## PIC24FJ128GA204 Family Silicon Errata and Data Sheet Clarification

The PIC24FJ128GA204 family devices that you have received conform functionally to the current Device Data Sheet (DS30010038C), except for the anomalies described in this document.

The following typographic corrections and clarifications are to be noted for the latest version of the device data sheet (DS30010038C):

**FIGURE 32-5: I<sup>2</sup>C BUS DATA TIMING CHARACTERISTICS (MASTER MODE)**

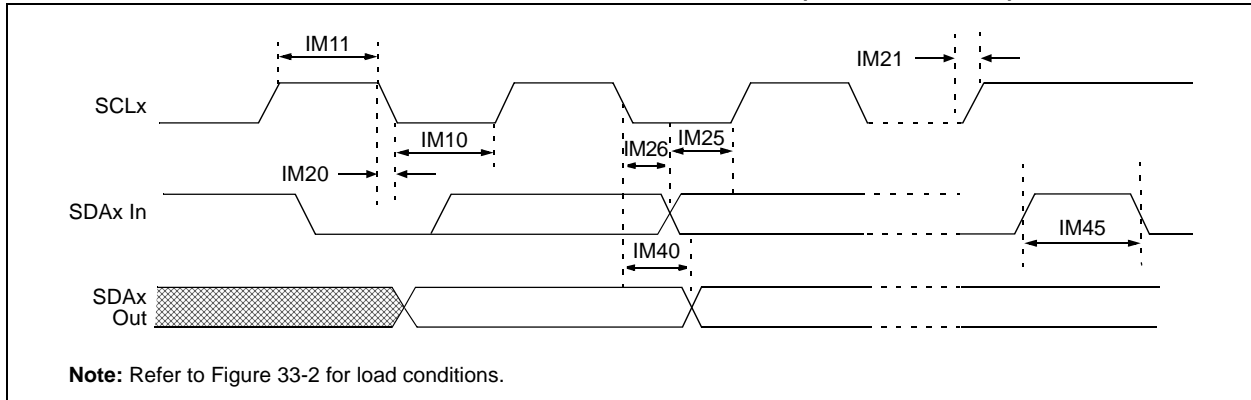
Figure 32-5 and Figure 32-7 are modified as shown in the figures below.
